Report: PRELIM
Function: Test, Adjust, & Balance
Date: 02/02/2024

PROJECT
Valvoline (Bellevue, WI)

Project: Valvoline (Bellevue, WI)

Access
02/02/2024

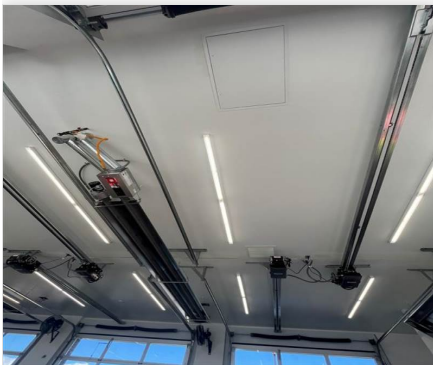
Issue Name : EF-2 / EF-3 Accessibility
Description : EF-2 and EF-3 in-line fans are mounted high above shop floor behind hard ceiling in attic space. A ladder or lift is needed to access ceiling hatch, and then it is necessary to crawl through insulation in 2ft high space. Not accessible.

1-1NoDamper
02/02/2024

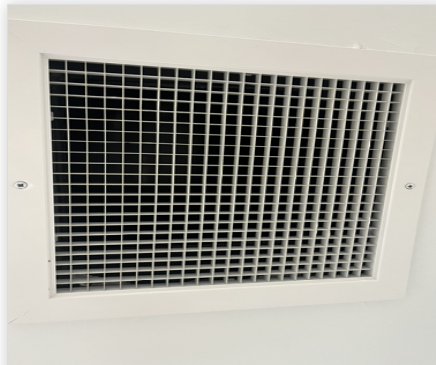
Issue Name : Return Dampers Missing
Description : Return dampers are not installed on returns 1-1 and 1-2. As a result, return airflow cannot be properly balanced. Recommend return dampers are installed.
Created By : National TAB **Assigned To :** National TAB - Michael McDonnell
Status : Open
Priority : **Asset Tag :**
Originated Date : 02/02/2024 - Michael McDonnell - National TAB
